STAFF REPORT

Agenda Title: For Possible Action: Discussion and possible action regarding a Tentative Subdivision Map known as Andersen Ranch to create 203 single family lots on 48.2 acres zoned Single Family 6000 (SF6) and Single Family 12,000 (SF12), on property located at 1450 Mountain Street, generally east of Ormsby Boulevard, west of Mountain Street, north of Washington Street, and south of Long Street, APNs 007-573-09, -10, and -11. (Hope Sullivan, hsullivan@carson.org)

STAFF REPORT FOR THE PLANNING COMMISSION MEETING OF DECEMBER 17, 2019

Figure 2 – Existing Zoning

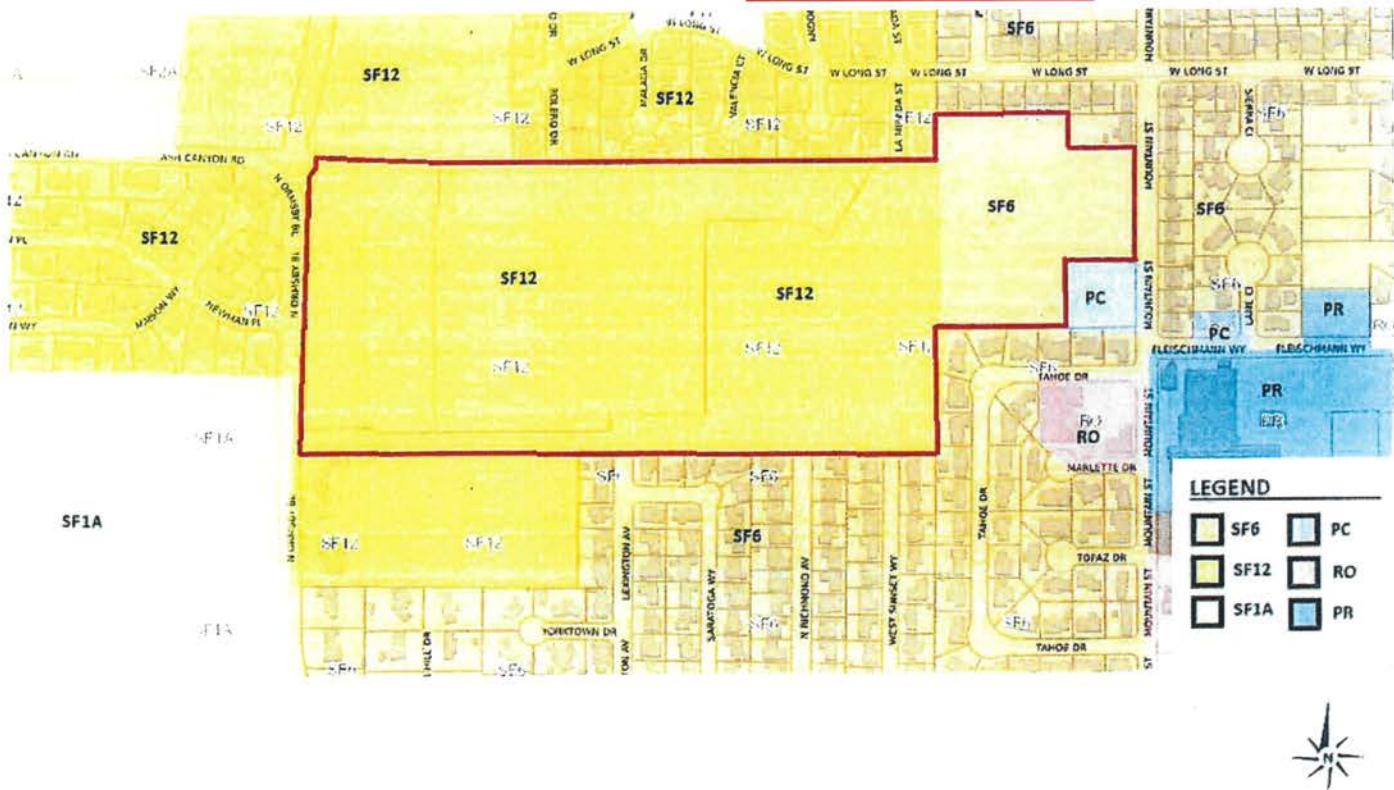
7.8 ac of SF6 = 56
40.4 ac of SF12 = 146
Total should be 202

Figure 4 – Aerial View

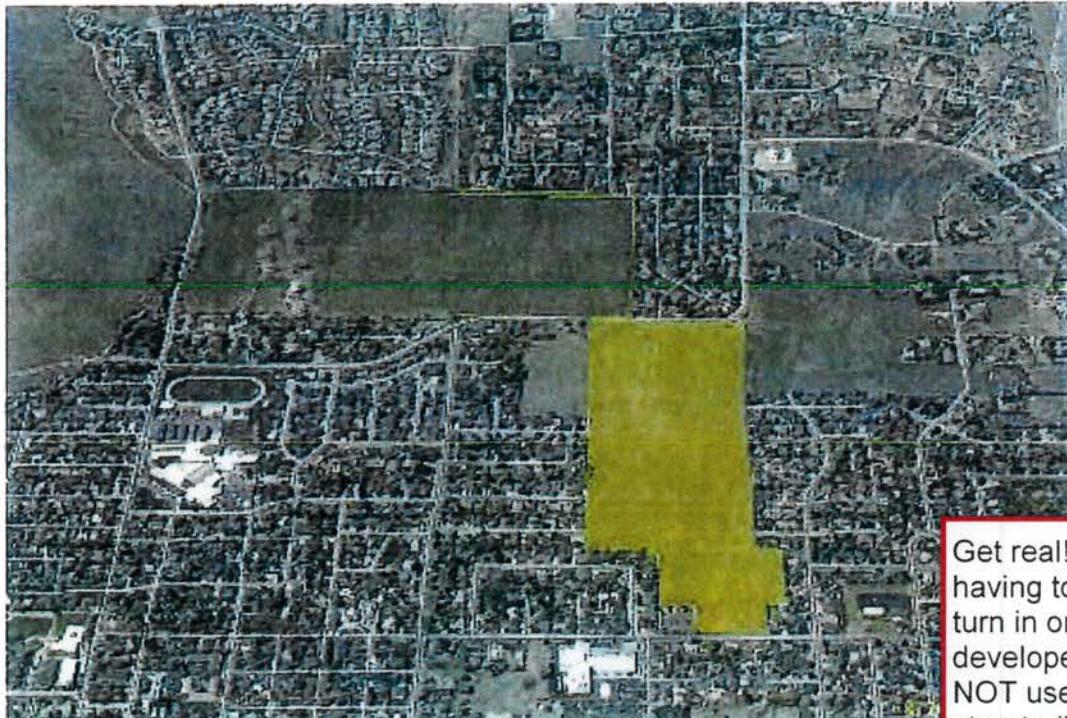
Get real!!! Anyone having to make a LEFT turn in or out of the development WILL NOT use the main streets (Mountain and Ormsby). They will cut thru the neighborhoods.

Figure 6 – Vintage Development Plan

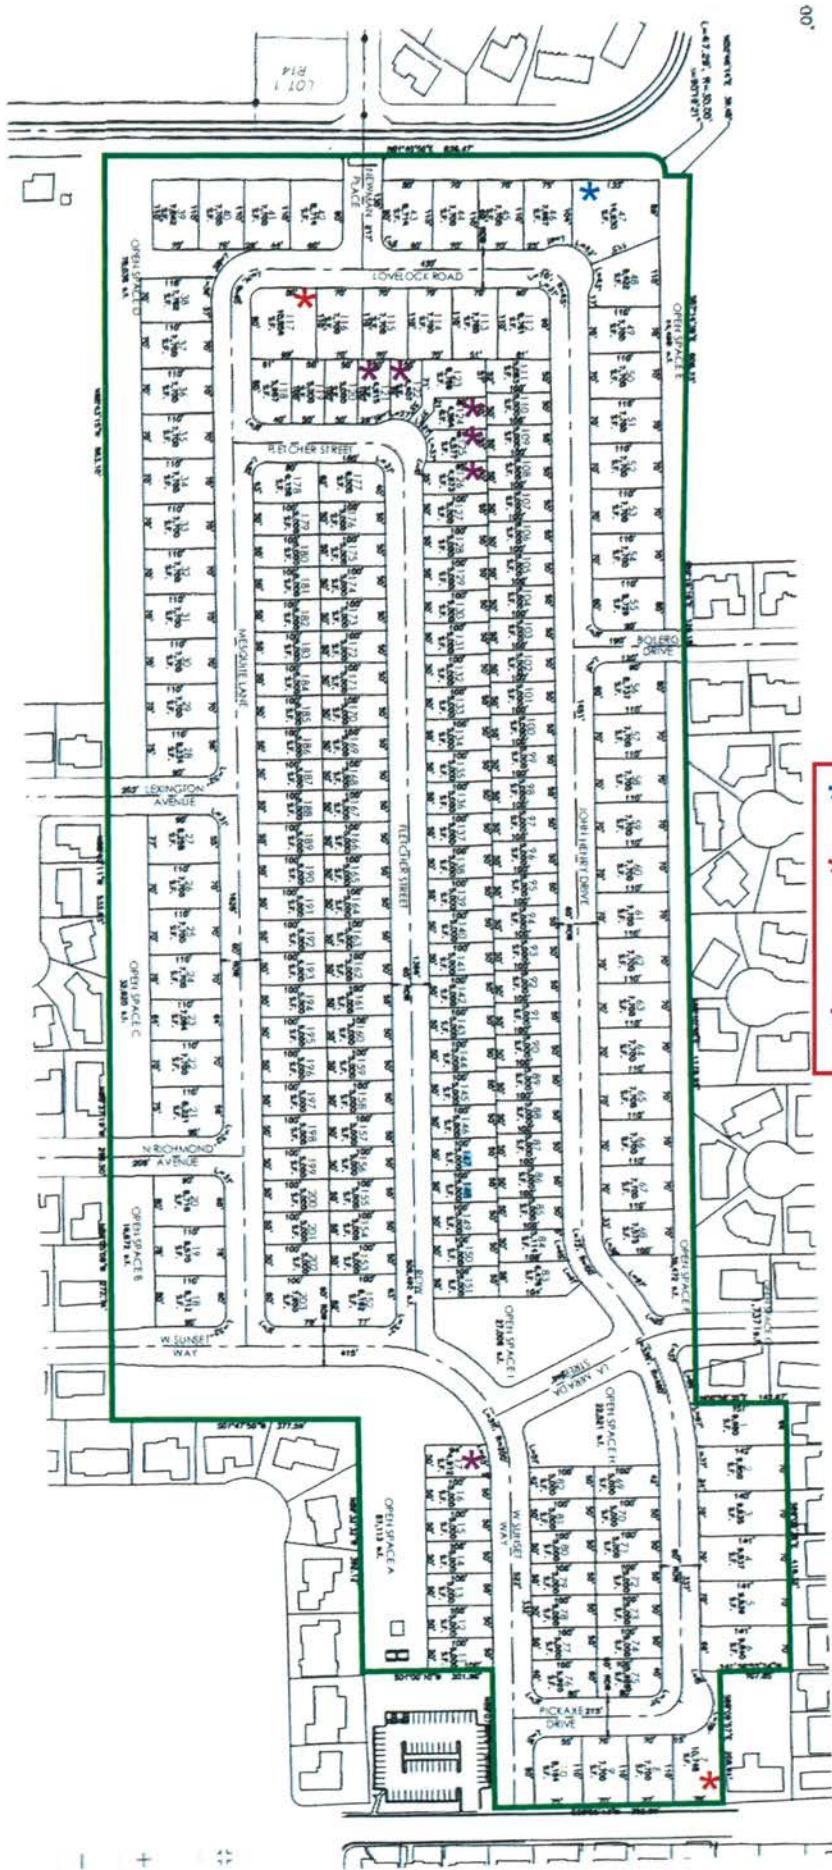
I don't see any clustering on your map!
